COUNTY OF SAN LUIS OBISPO  
BOB JONES PATHWAY  
(SAN LUIS OBISPO TO ONTARIO ROAD)  
FINAL ENVIRONMENTAL IMPACT REPORT

COUNTY OF SAN LUIS OBISPO  
**BOB JONES PATHWAY**  
**(SAN LUIS OBISPO TO ONTARIO ROAD)**  
FINAL ENVIRONMENTAL IMPACT REPORT

2.0 Response to Comments ..... 2.0-1

Exhibit A  
DEIR Alignment

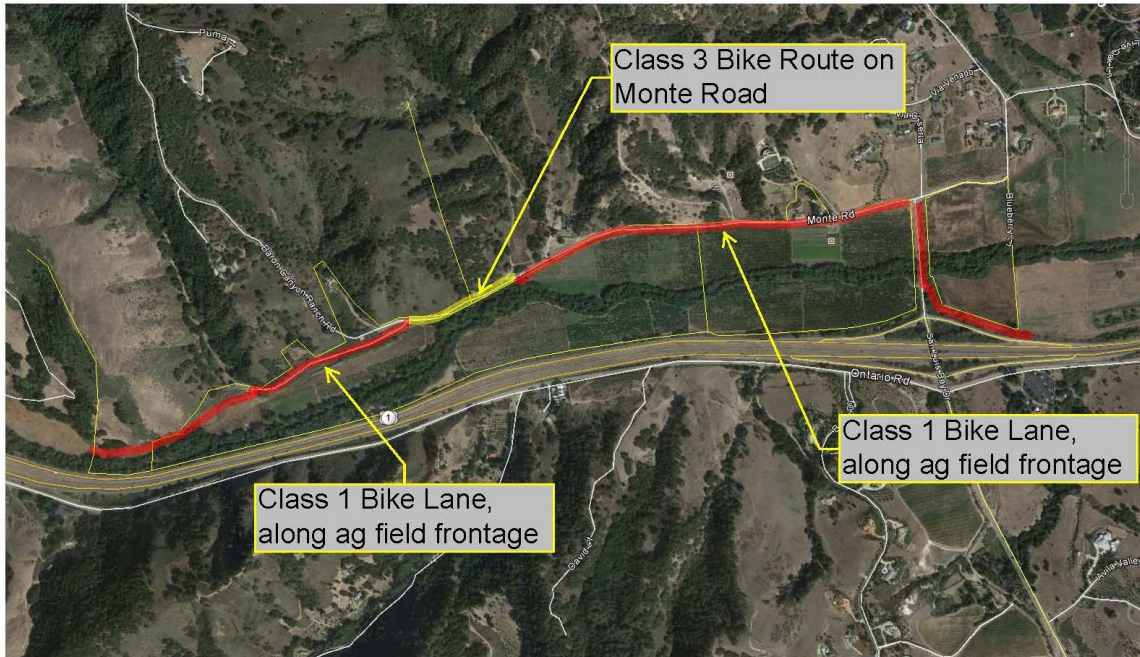
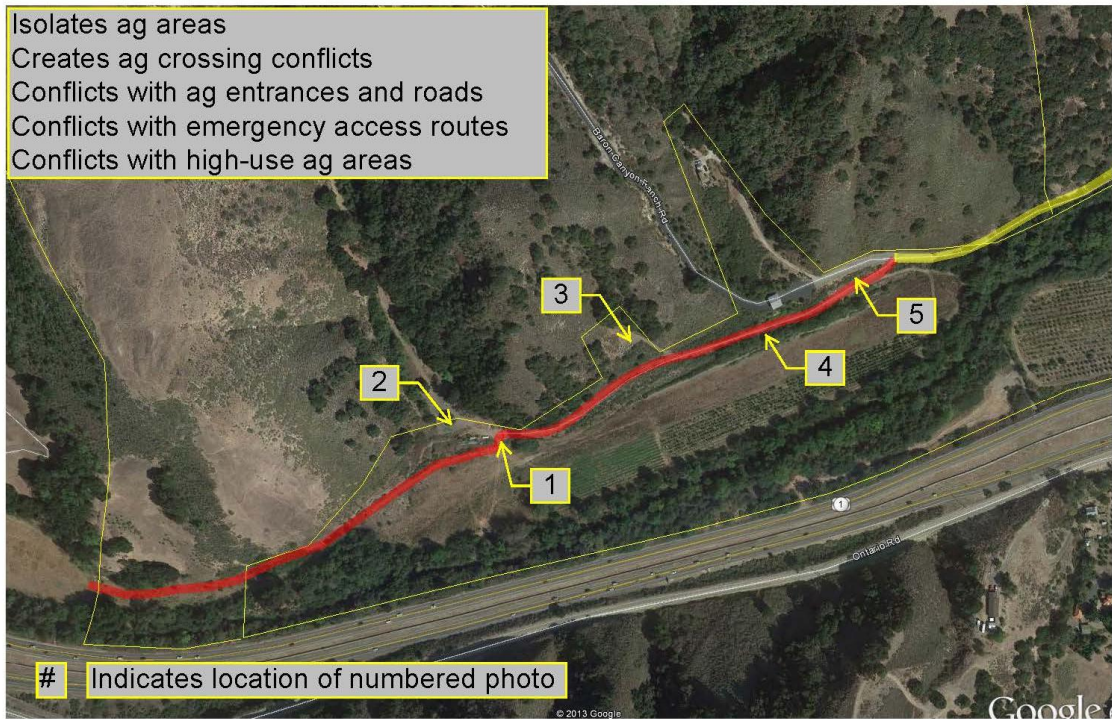
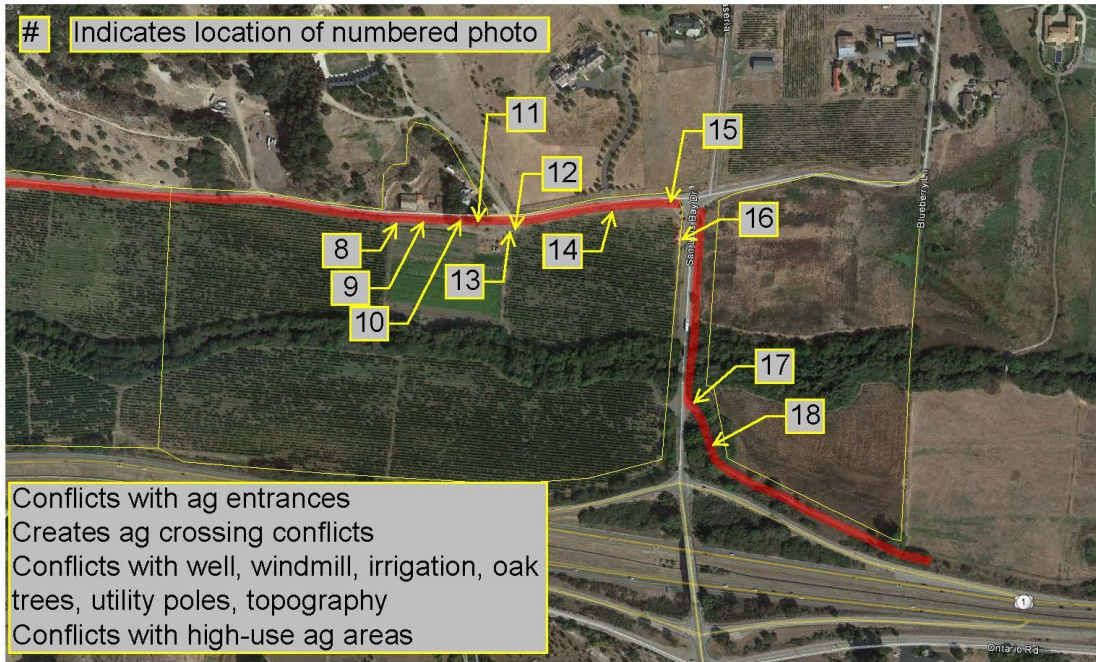
The DEIR proposed route has the following Impacts that were not identified or sufficiently addressed in the DEIR. These issues are also shown on the attached exhibits and annotated photo, which show additional detail to be considered.

1. The DEIR proposed bike lane isolates existing agriculture use areas from the primary farm fields. In order to continue utilizing the isolated area, new agricultural crossings need to be identified on the DEIR, and all the crossing conflicts addressed.
2. In some areas, the separation means that instead of one agricultural road, two will be needed, and this is added lost use of farm land that needs to be identified as an impact, and mitigated

1. The DEIR proposed bike lane eliminates several areas of functional importance to the farming operations. These include areas used for employee parking, vehicle turning, loading and unloading, equipment storage, and irrigation.
2. The DEIR needs to identify the loss of these areas and show how and where they will be replaced. The lost areas of functionality need to be included in the area of agricultural impact and mitigated.
